Pamela Abee-Taulli
Environmental Program
Coordinator
Development Services
Department

PINNACLE AT WILDHORSE RANCH

**12000 BLUE BLUFF RD,
AUSTIN 78724
C8-2021-0152**

VARIANCE REQUESTS

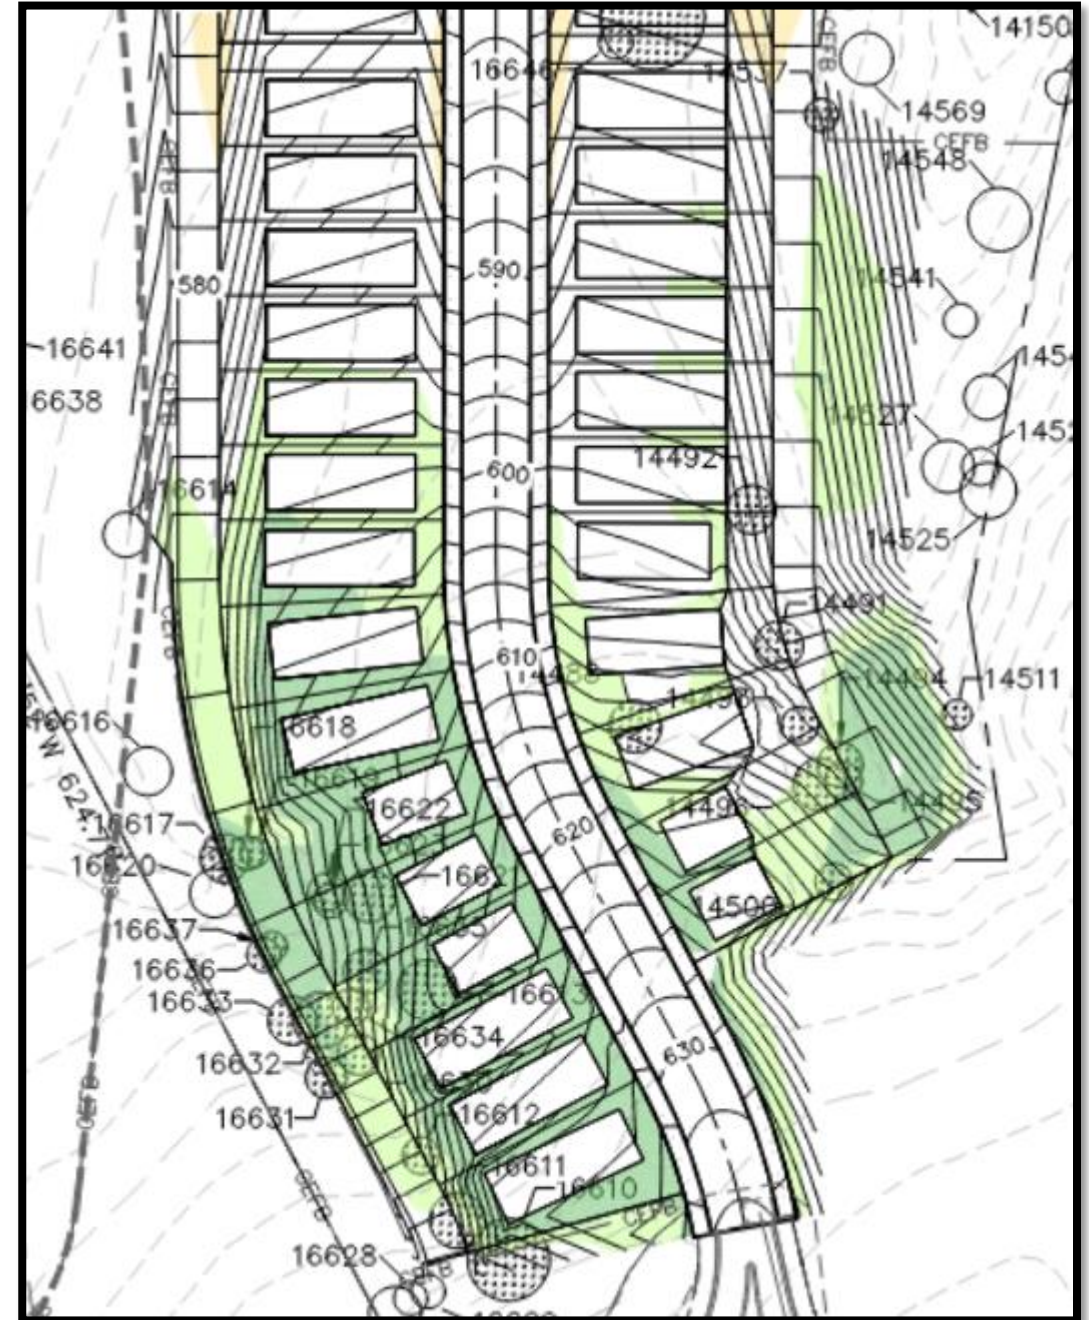
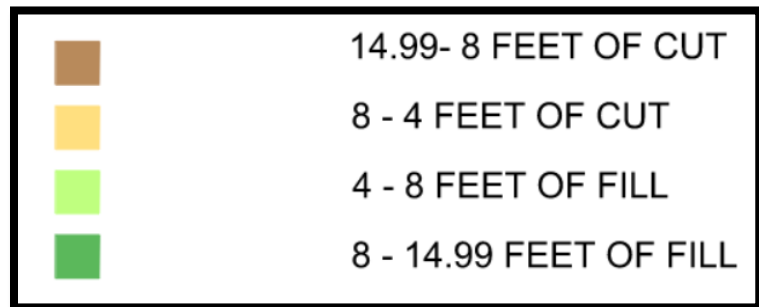
1. Cut to 15
2. Fill to 15

VARIANCE REQUESTS

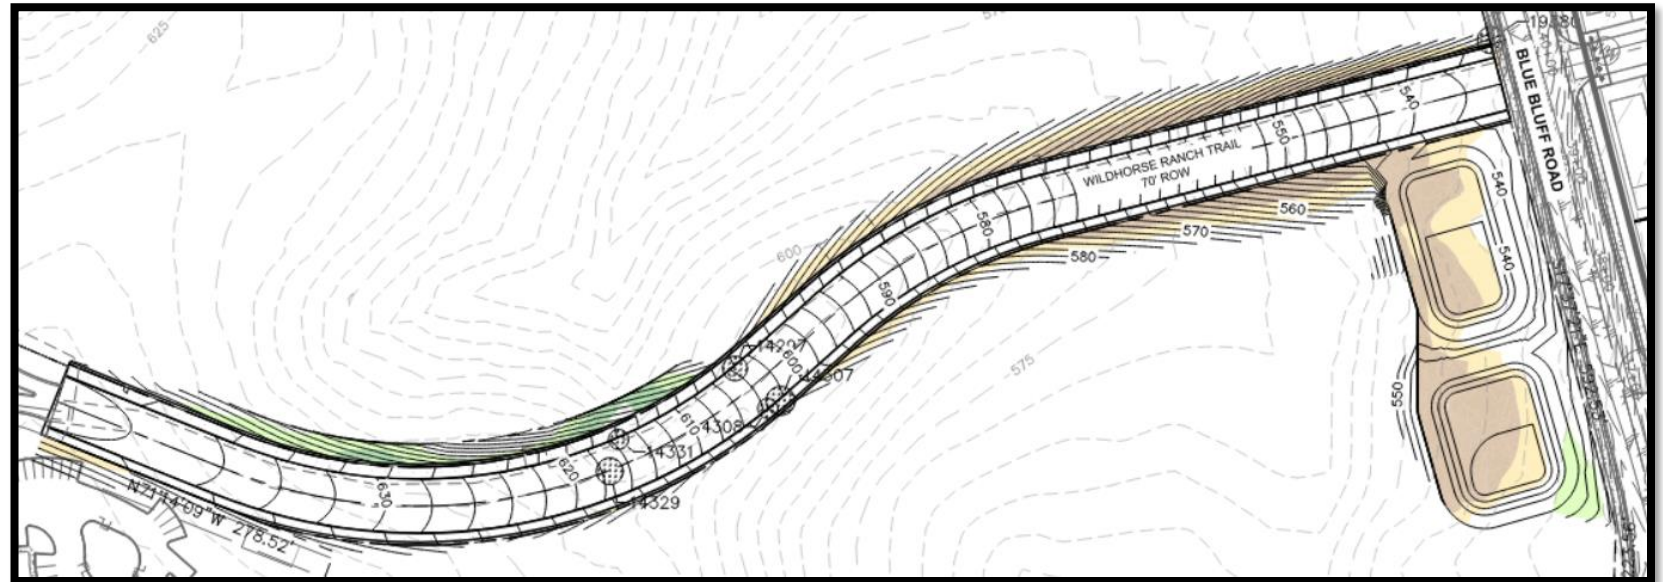
1. Cut to 15
2. Fill to 15

14.99- 8 FEET OF CUT
	8 - 4 FEET OF CUT
	4 - 8 FEET OF FILL
	8 - 14.99 FEET OF FILL

VARIANCE REQUESTS BACKGROUND

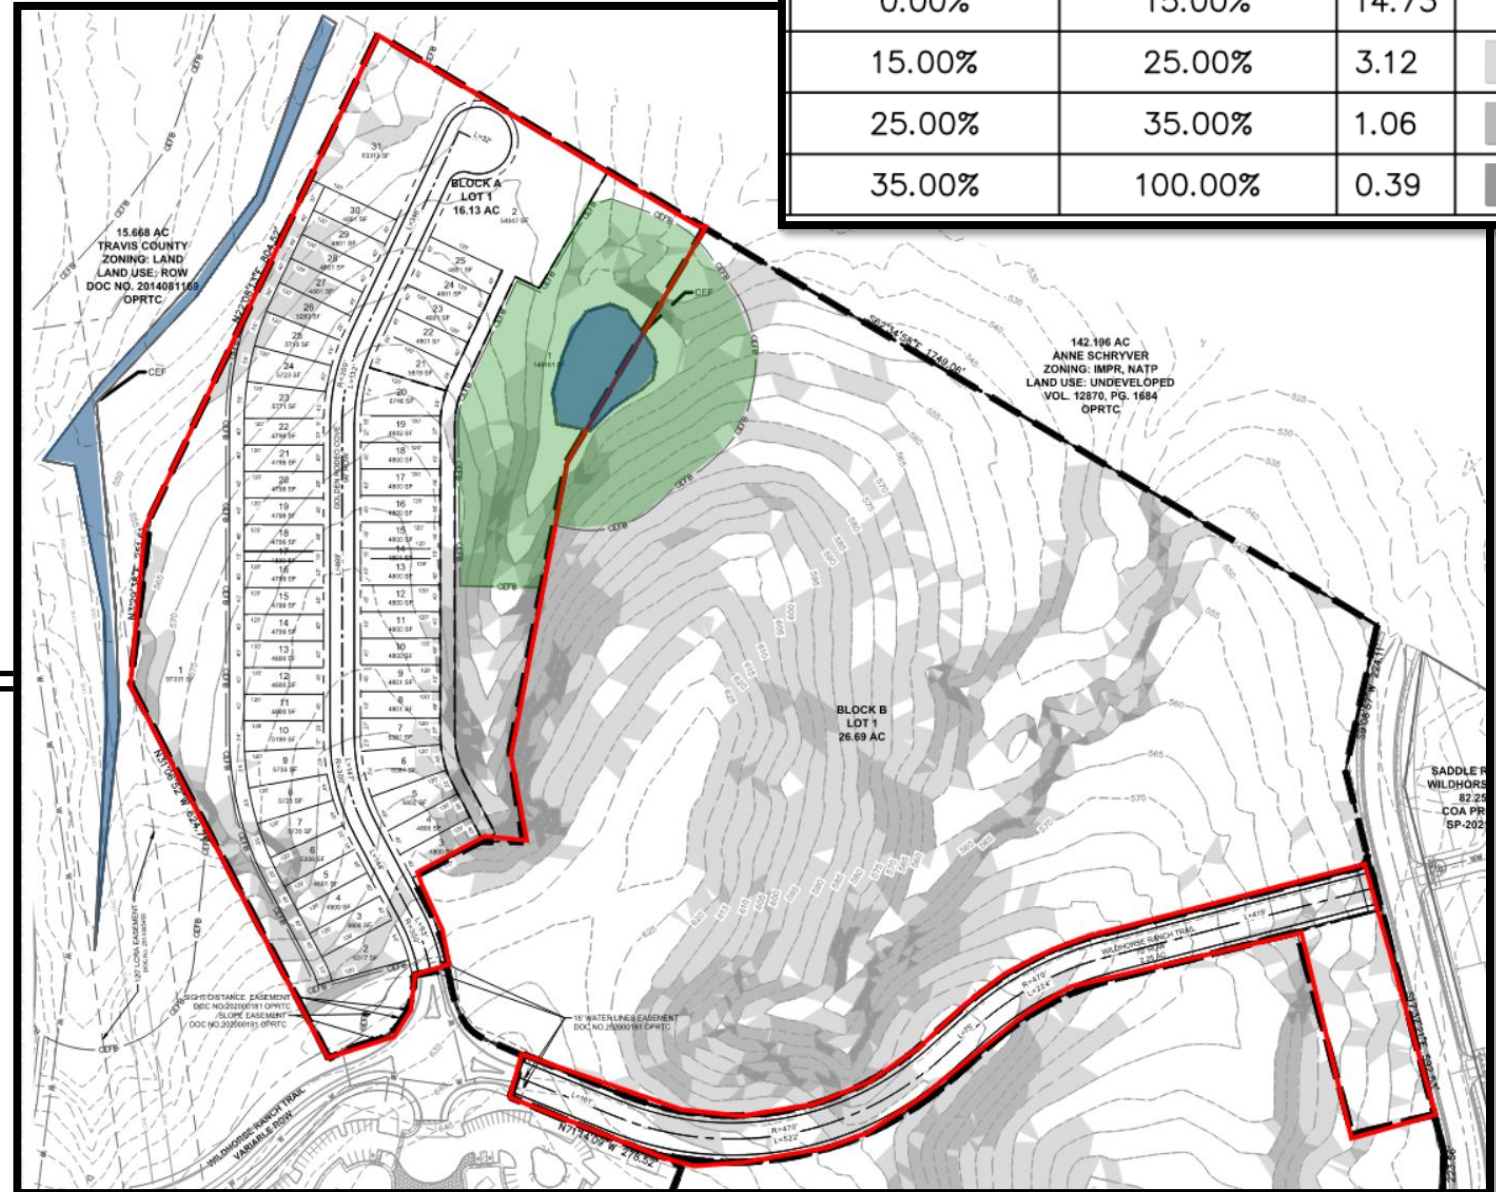
- Slopes at or exceeding 15 percent grade.
- Two wetland Critical Environmental Features (CEF)

1. The applicant will provide enhanced vegetation for the wetland critical environmental features.
2. Grading over 8 feet will be terraced or contained with walls.
3. Water quality requirements will be met by using biofiltration, a green storm water quality infrastructure.
